ADDENDUM NO. 3

DATE: July 24, 2015

Contract 15-C-00046; Furnish and Install Miscellaneous Water & Stormwater Mains 2"- 48" Diameter - FY16

| <p>TAMPA WATER DEPARTMENT</p> | <p>APPROVED <u>Sept. 2011</u></p> | <p>REVISED _____ _____ _____</p> | <p>AUTOMATIC AIR RELEASE VALVE</p> | <p>2.14</p> |

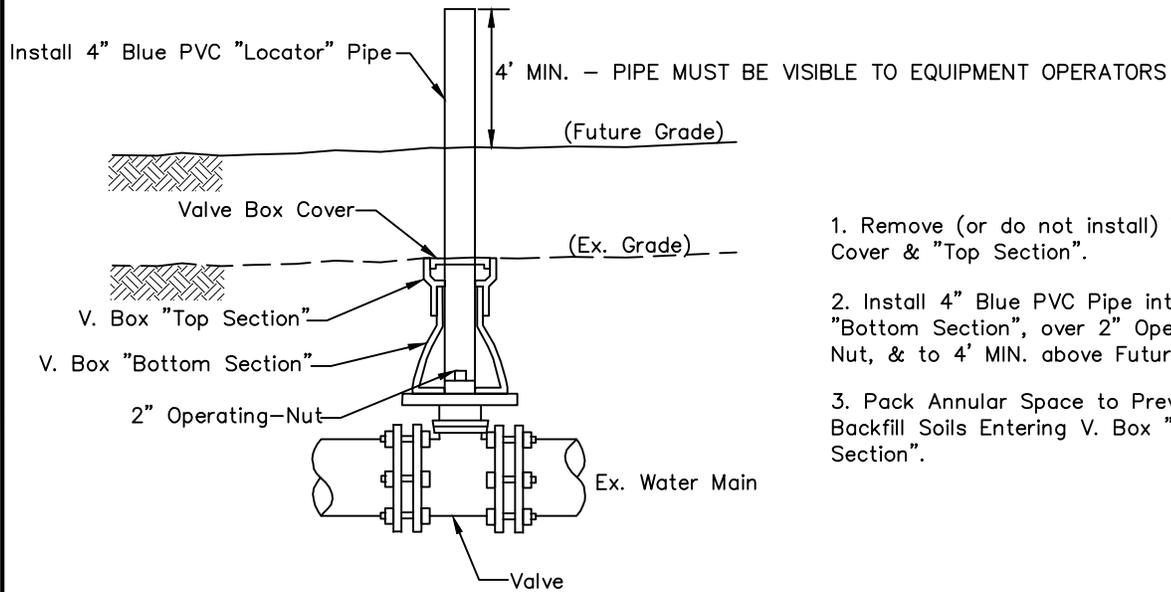
Item 45: Replace Detail 2.14 with updated Detail 2.14

1. Air Release Valve to be installed inside of a Charles Ind. buried, square, split pedestal with low profile dome or approved equal. Pedestal can be purchased from D. H. Supply (contact Buzz Kraftt @ D.H. Supply, 1-866-347-4677)
2. Lock mechanism to be located min. 2" above finish grade.
3. Pedestal base to be placed on 4" thick, compacted gravel bed.
4. Screened opening of the standpipe to be 12" min. above finish grade.

|  TAMPA WATER DEPARTMENT | APPROVED | REVISED | VALVE BOX (V. BOX) ADJUSTMENTS FOR GRADE CHANGE | 3.05 |

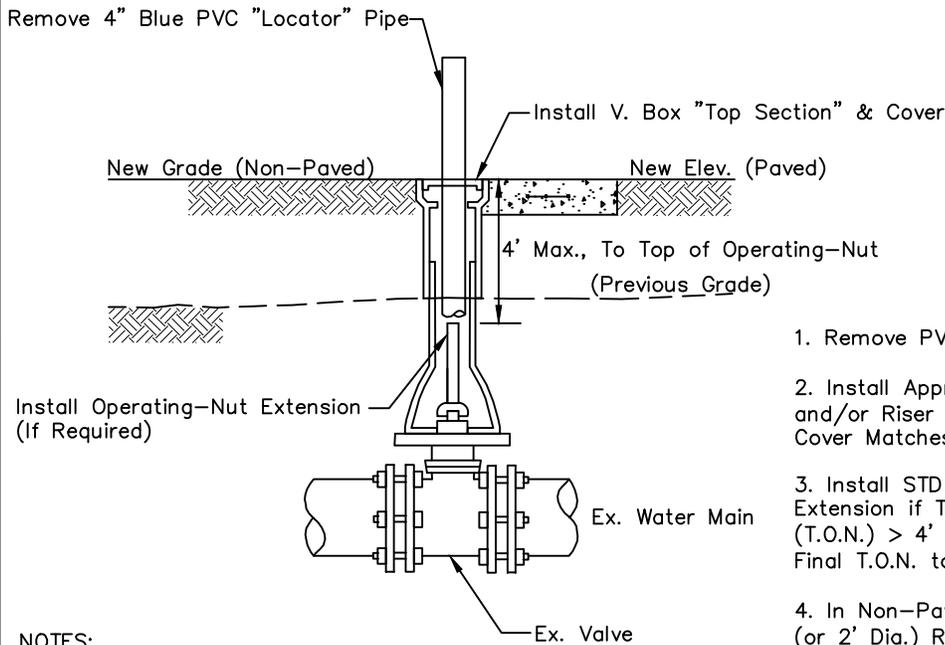
Item 36: Replace Detail 3.05 with the updated attached version.

Item 46: Replace Detail 3.05 with updated Detail 3.05

Valves shall be furnished with extension stems if operating nut is greater than 48-inches deep, to bring the operating nut to within 24-inches of the top of the valve box (see Detail 3.05, #3). Connection to the valve shall be with a wrench nut coupling and a set screw(s) to secure the coupling to the valve’s operating nut. The coupling and square nut wrench shall be welded to the extension stem. Rock guard and centering plate are required. Extension stems shall be equal to or better than ProSelect Gate Valve Extension – with Centering Plate, or Trumbull Gate Valve Extension Stems, Style B.

| TAMPA WATER DEPARTMENT | APPROVED | REVISED | CONCRETE VALVE BOX COLLAR DETAIL | 3.06 |

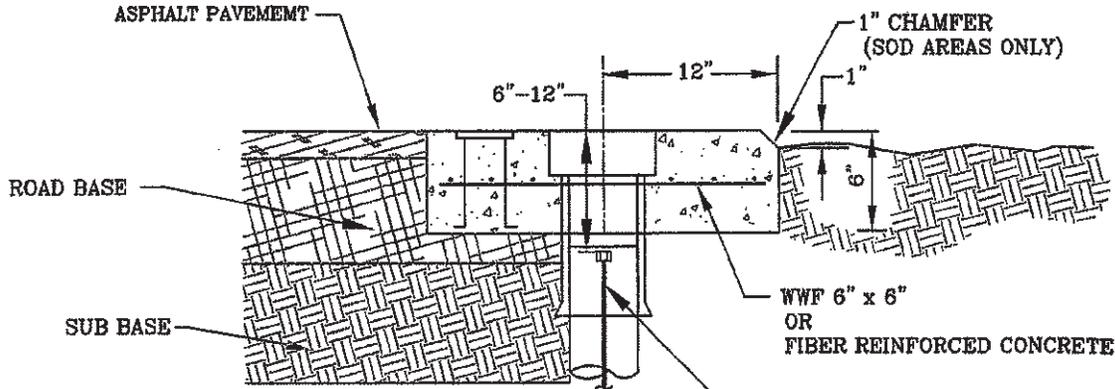
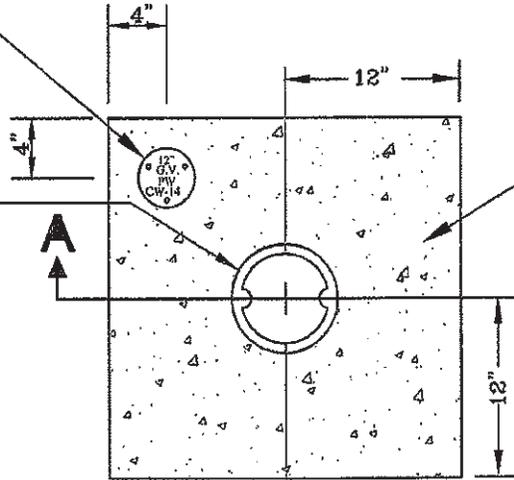
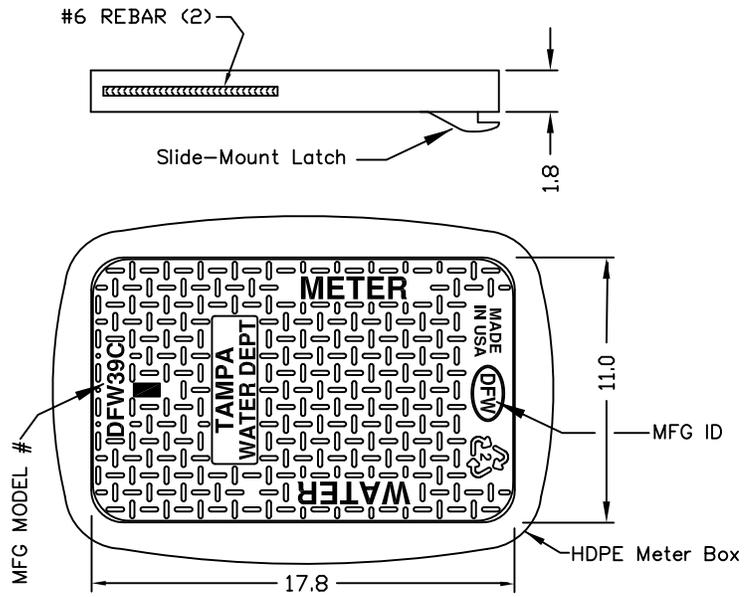
Item 47: Insert Detail 3.06

Item 52: In Technical Specifications – WATER, page TS-37, Section T2.08, end of 3rd paragraph, add: Bronze valve identification disks (3” OD x 8” thick) are required for all valve installations, per Detail 3.06.

| <p>TAMPA WATER DEPARTMENT</p> | <p>APPROVED Sept. 2011</p> | <p>REVISED _____ _____ _____</p> | <p>3/4" OR 1" SINGLE SERVICE HDPE METER BOX</p> | <p>5.10A</p> |

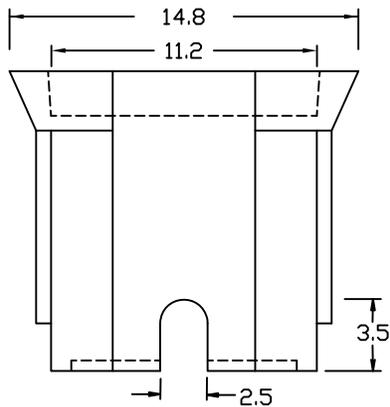
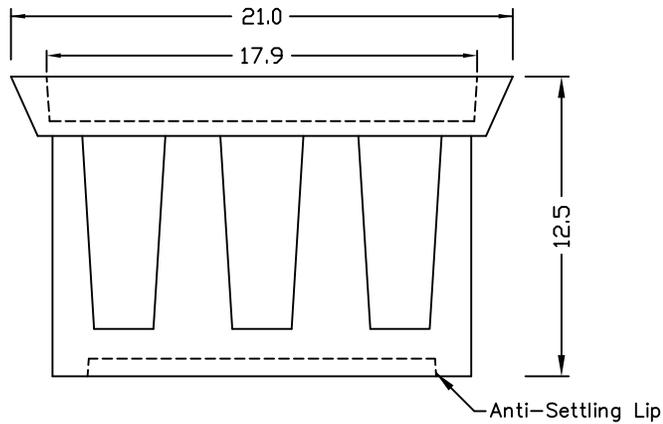
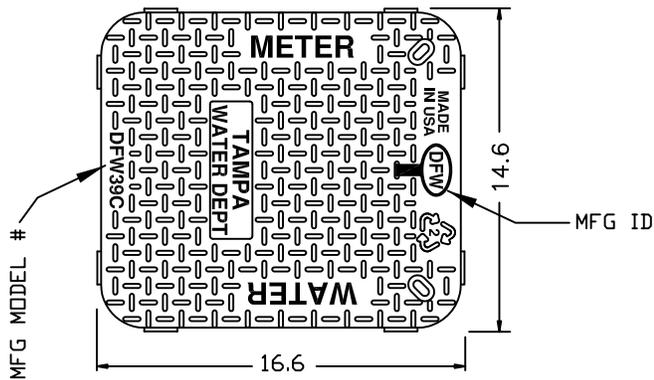
Item 48: Replace Detail 5.10A with updated Detail 5.10A

| <p>TAMPA WATER DEPARTMENT</p> | <p>APPROVED Sept. 2011</p> | <p>REVISED _____ _____ _____</p> | <p>3/4" OR 1" DUAL SERVICE HDPE METER BOX</p> | <p>5.11A</p> |

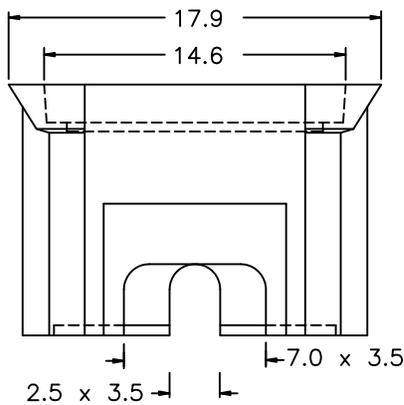
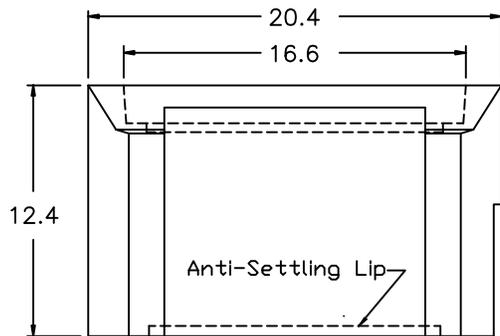
Item 49: Replace Detail 5.11A with updated Detail 5.11A

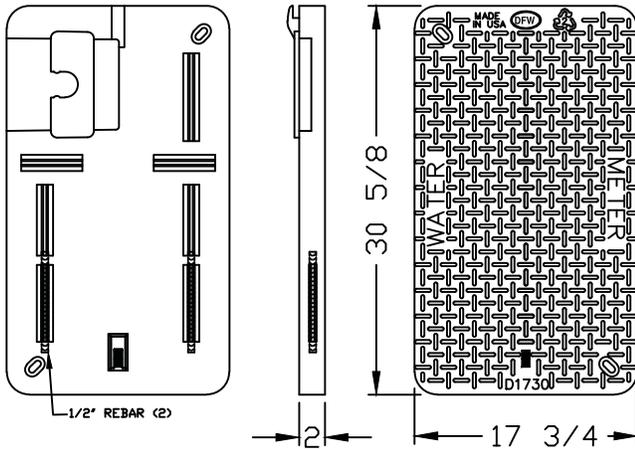
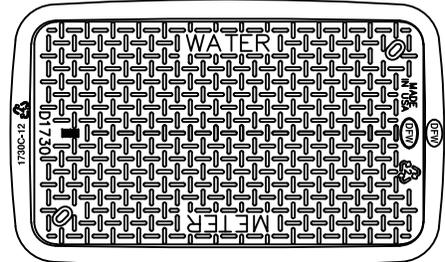
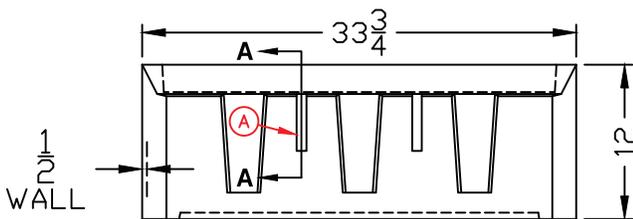
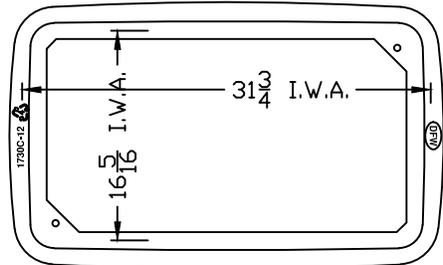
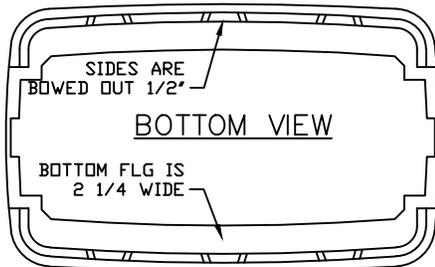
Item 50: Insert Detail 5.12A
